AEROPRAKT

SERVICE BULLETIN

No. SB A-22LS-26

UPGRADE OF A-22LS FLEET IN GERMANY TO TYPE DESIGN PER TYPE CERTIFICATE DATA SHEET No. 991-22 1

Photo 1

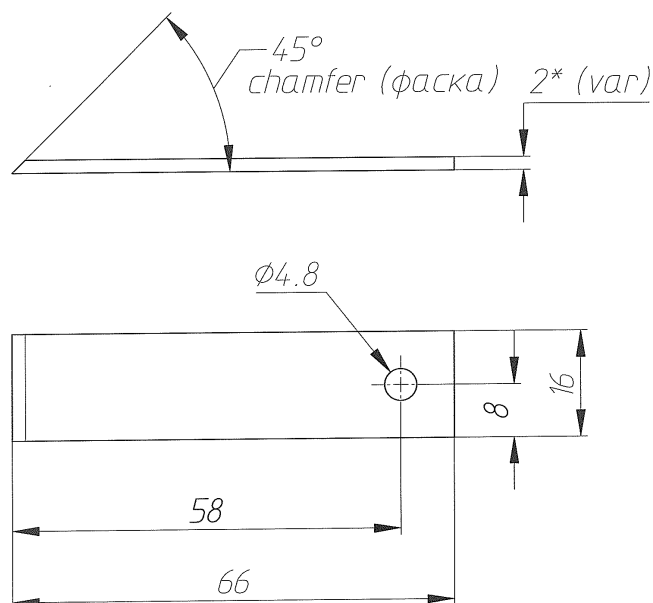
3.1.1. In order to attach the rubber cords to fuselage it is necessary to drill on each fuselage side a hole in the fuselage beam flange forward of frame No 2. The hole center must be at 58 mm distance from frame No.2 and at 8 mm from the flange edge. (See the drawing and the photo of the drilling template below.)

Photo 7

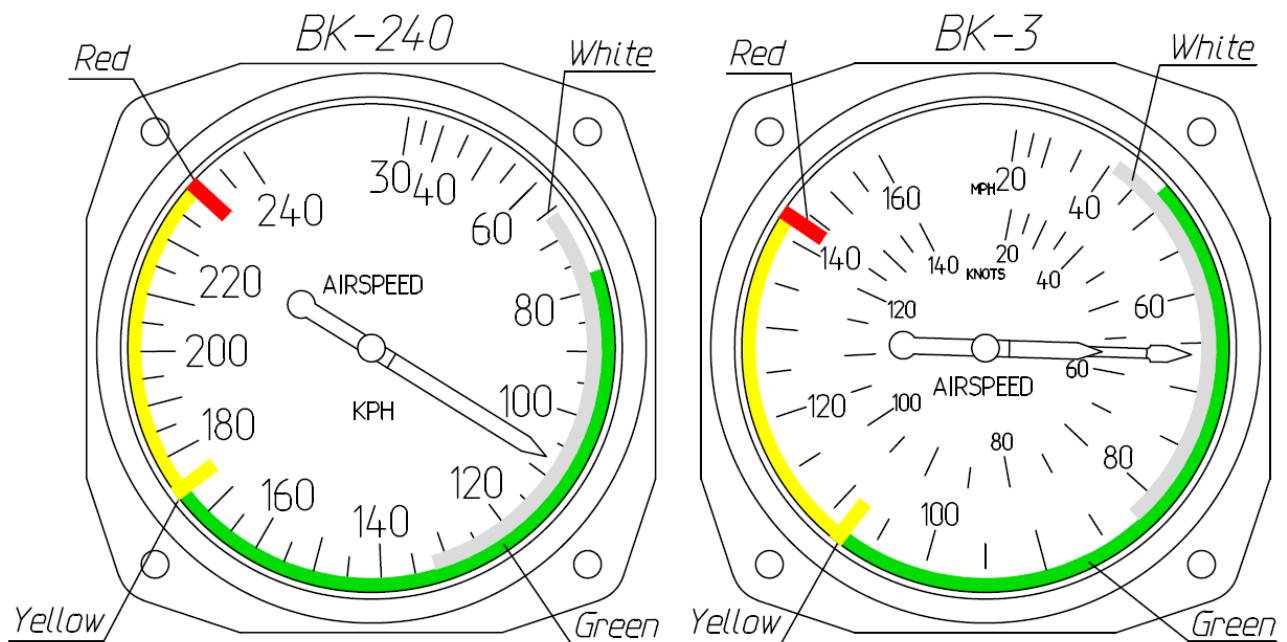
Replace the old placard with luggage weight limit of 30 kg to the new one with the temporary luggage weight limit of 10 kg (see photo 7).

**3.4) Replace the weight limitation placard on the instrument panel**

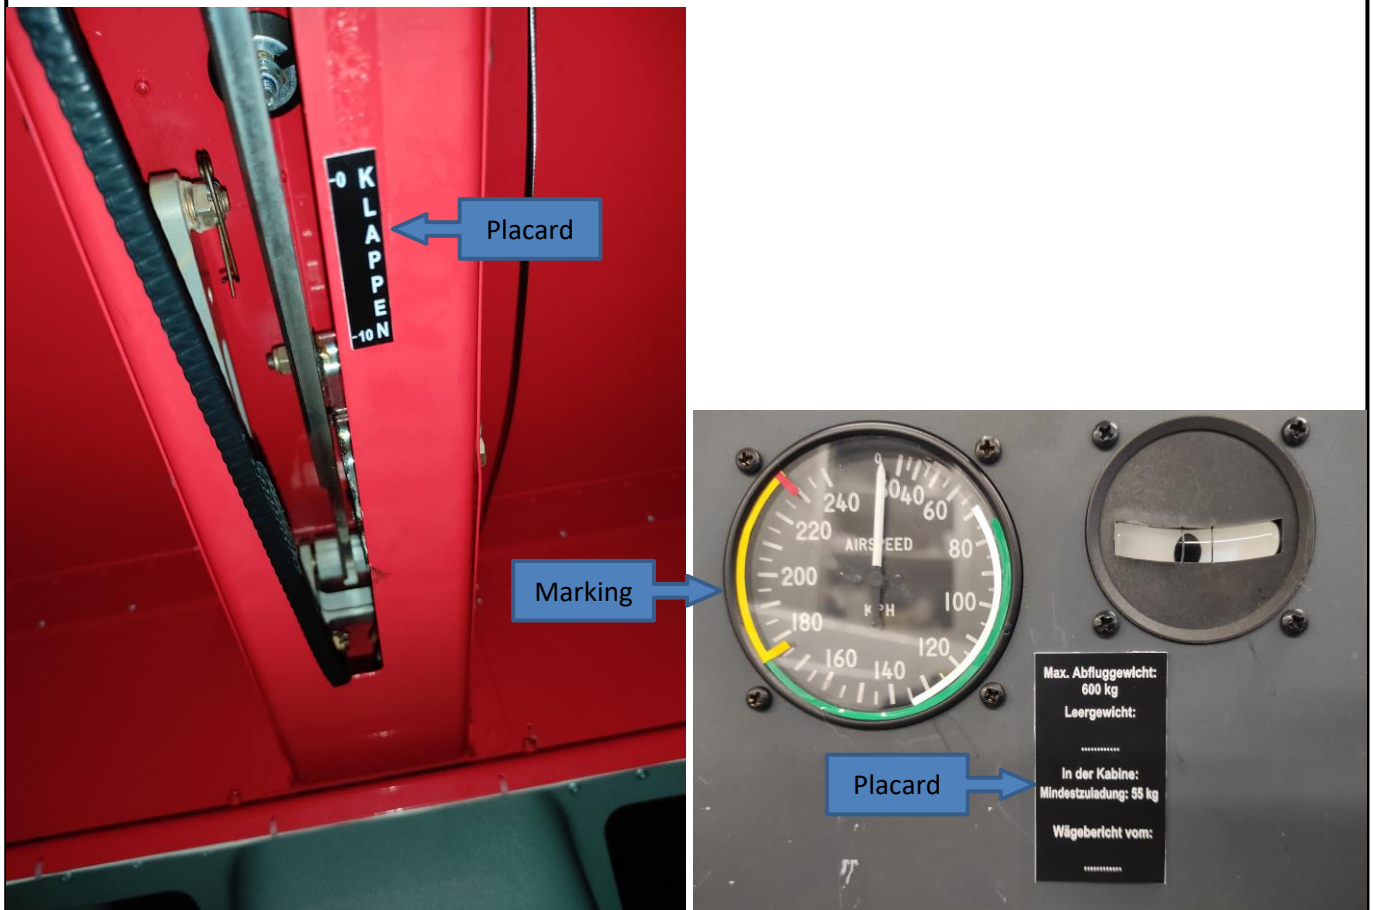
Replace the old weight limitation placard on the instrument panel with the new one (supplied by local dealer).
